CHANGE ORDER NO. 2

OWNER	City of Baxter	DATE	June 24, 2024
CONTRACTOR	RL Larson Excavating, Inc.	SEH No.	BAXTE 172114
ENGINEER	SEH	City No.	4138
Project	2024 South Forestview Area Improvements, Baxter

DETAILS

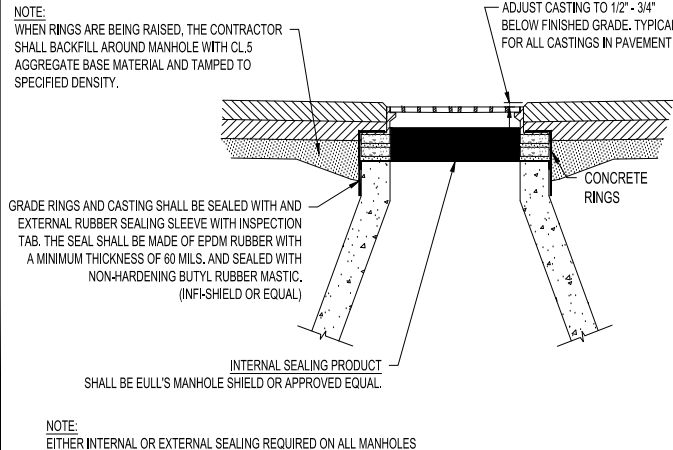
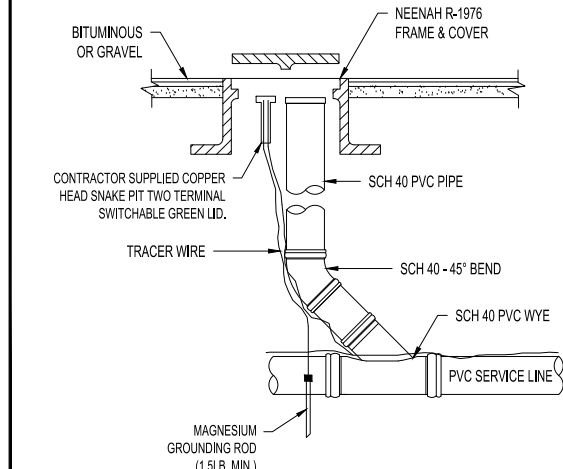
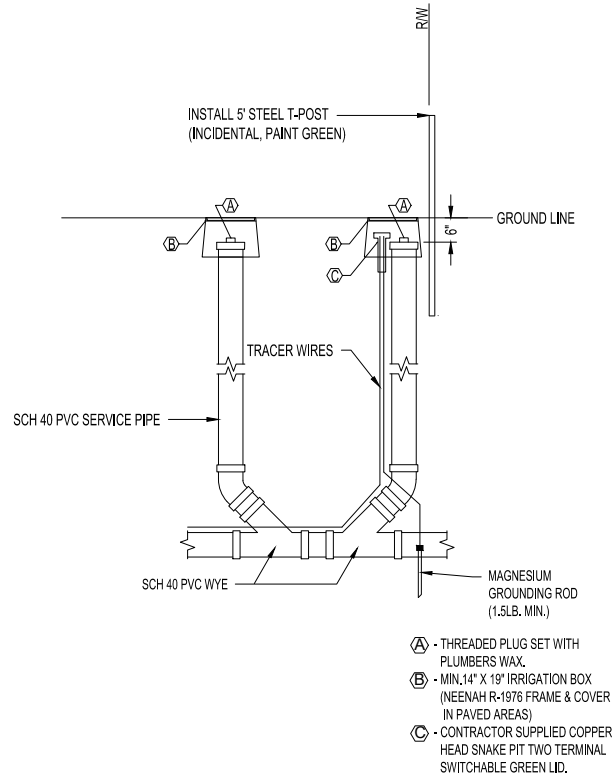
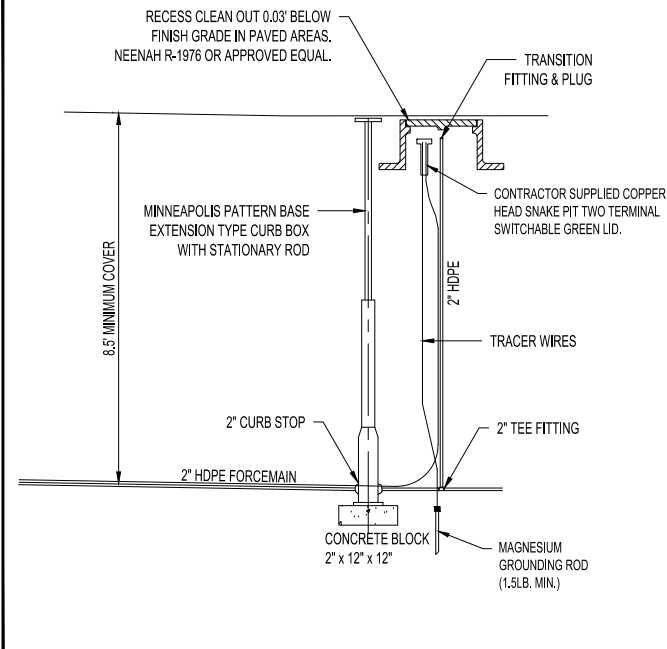
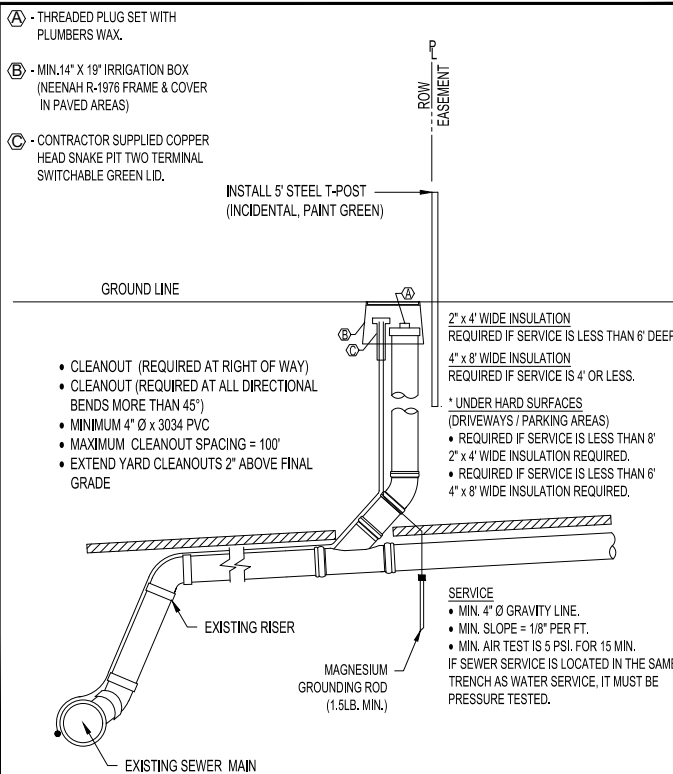
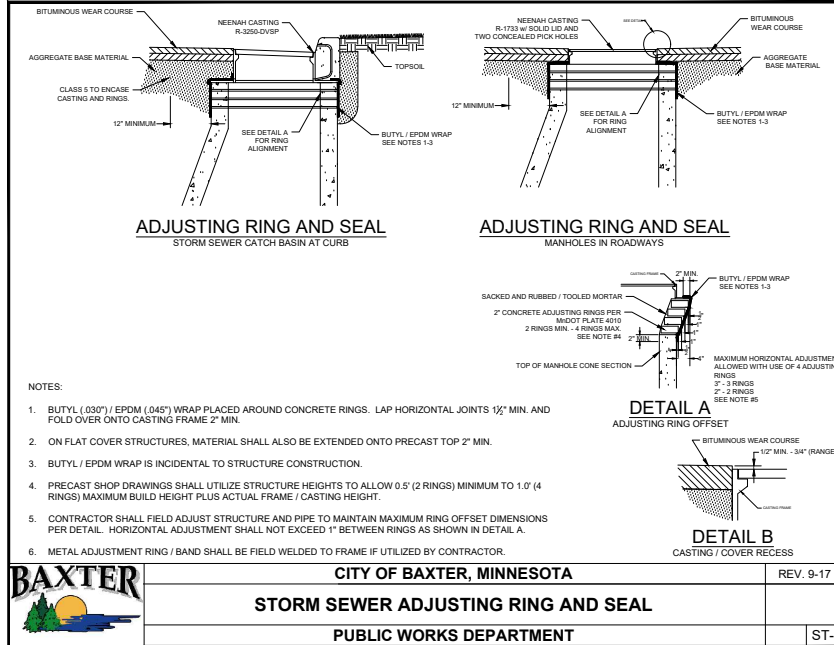
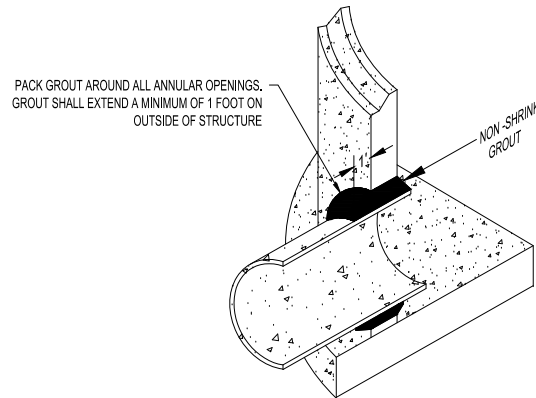
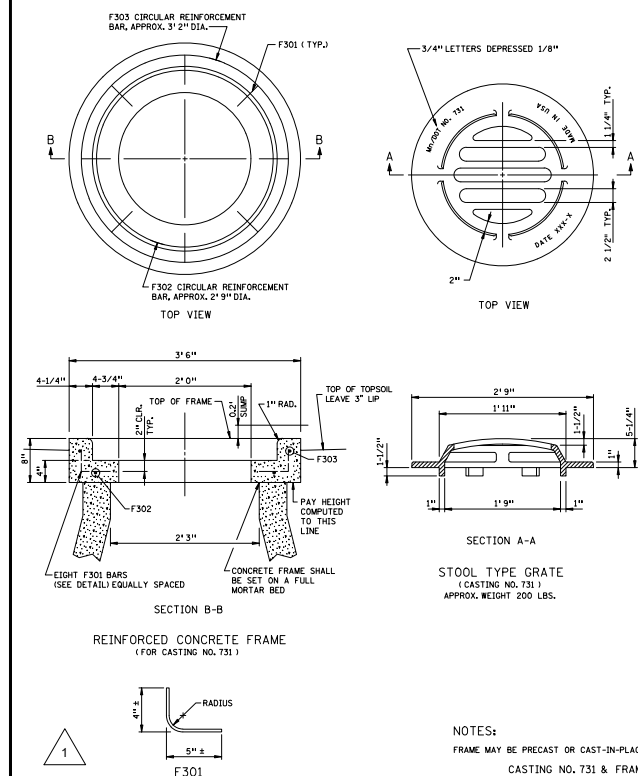
SEH Project	BAXTE172114	Rev. #		Revision Issue Description	Date	Rev. #		Revision Issue Description	Date
Drawn By	TJS		
Designed By	TJS		
Checked By	NH	1		ADDED STORM SEWER DETAILS	05/23/2024	.	.
